CITY OF ALBUQUERQUE

**Re: NOBIS Rehab Hospital
1100 Woodward PL NE
Albuquerque, NM 87012
Traffic Circulation Layout
Engineer's Stamp 01-29-26 (J15D053)**

The TCL submittal received 02-20-2026 is approved for Building Permit by Transportation. A copy of the stamped and signed plan will be needed for each of the building permit plans. Please keep the original to be used for certification of the site for final C.O. for Transportation.

NOBIS REHAB HOSPITAL 1100 WOODWARD PL.	DRAWN BY pjm
	TRAFFIC CIRCULATION PLAN	DATE 1-29-26
1-29-26 RONALD R. BOHANNAN P.E. #7868	TIERRA WEST, LLC 5571 MIDWAY PARK PL NE ALBUQUERQUE, NEW MEXICO 87109 (505) 858-3100 www.tierrawestllc.com	SHEET # SP-1
		JOB # 2023123

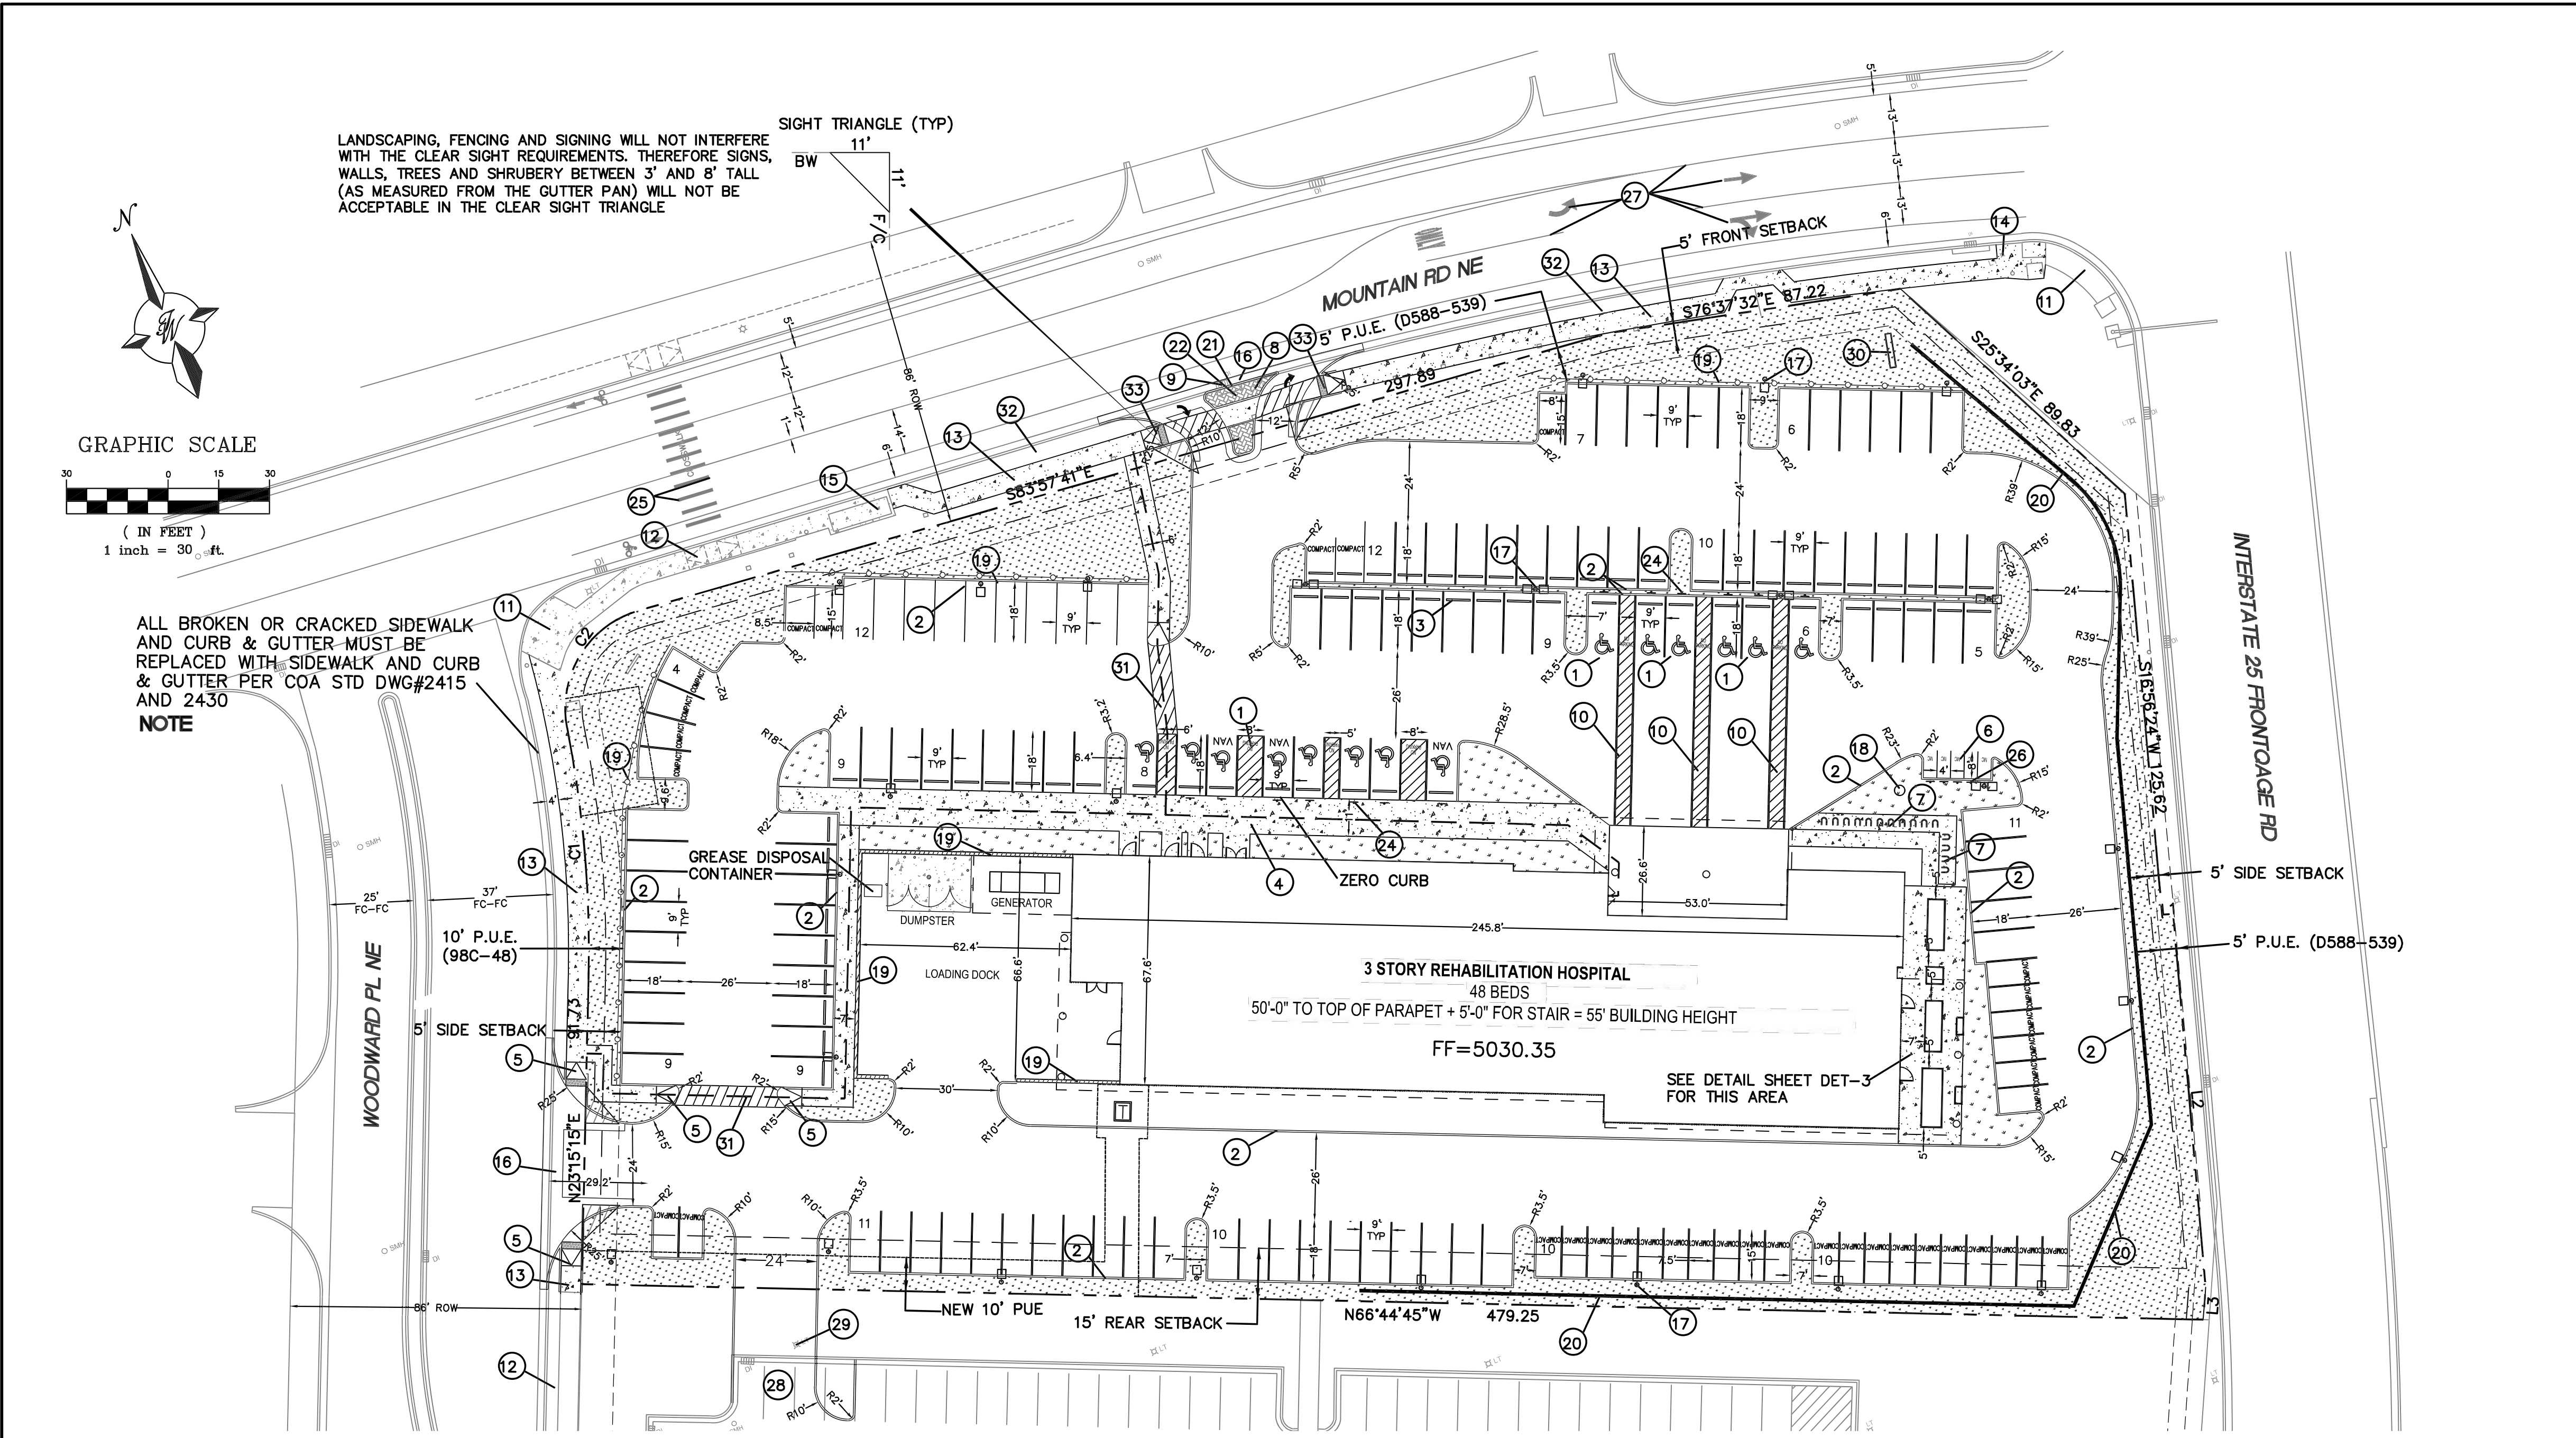
When the site construction is completed and an inspection for Certificate of Occupancy (C.O.) is requested, use the original City stamped approved TCL for certification. Redline any minor changes and adjustments that were made in the field. A NM registered architect or engineer must stamp, sign, and date the certification TCL along with indicating that the development was built in "substantial compliance" with the TCL. Submit this certification and the TCL to ABQ-Plan for log in and evaluation by Transportation. **SHARED ACCESS EASEMENT AND/OR APPROVED PLAT ARE CONDITIONS FOR RELEASING THE FINAL CO.**
